GENERAL MOTORS 4L60E/4L65E/4L70E

Several changes have occurred on the 700R4/4L60E family of transmissions since 1982. One of the more recent design changes, which started to be phased into early 2006 models, has resulted in another model name, 4L70E.

An input speed sensor (ISS or TSS) was added due to a computer strategy change, which has affected several components. All components from a specific design level must be used as a set, or durability/functionality issues will occur (**NOTE:** this does not apply to all 2006-Up models).

Pump Cover/Shaft

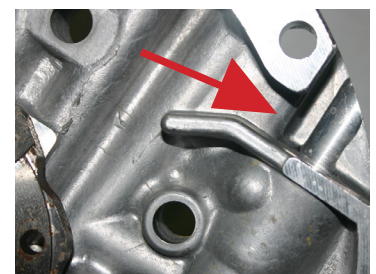
Changes in the pump cover were phased in beginning in early 2006, and specific model applications will dictate which design is required. The key here is having the right combination. There are three main areas of concern:

1. Is the hole drilled for the ISS or not?
2. Does the stator support sleeve have the large sensor hole?
3. Does the cover require the long or short boost valve/sleeve?

The newest cover casting #24230672 has a cut-out for the harness plug, and requires the short boost valve/sleeve.

The cover may or may not be drilled for the ISS or have the large hole stator sleeve. If the cover is drilled for the ISS and has the large sensor hole in the sleeve, it must be matched to a reluctor type input shaft due to the ring grooves/stator sleeve holes being repositioned (regardless of the reluctor grooves being cut).

ISS Harness Pathway

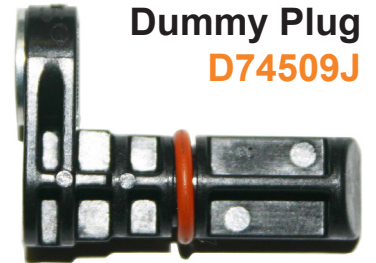
NOTE: Earlier interim covers I.E. (24206611, HX024075) have
different arrangements as well.

1. Fill in the ISS hole with either the sensor **D74438G** or dummy plug/
O-ring **D74509J** depending on requirements.
2. Use the proper input shaft/stator sleeve match as well as the correct
length of input/stator (298mm short/300mm long).
3. Ensure the correct boost valve/sleeve is used, based upon the bore
depth of the cover or oil hole position, or PR spring compression
will be affected.
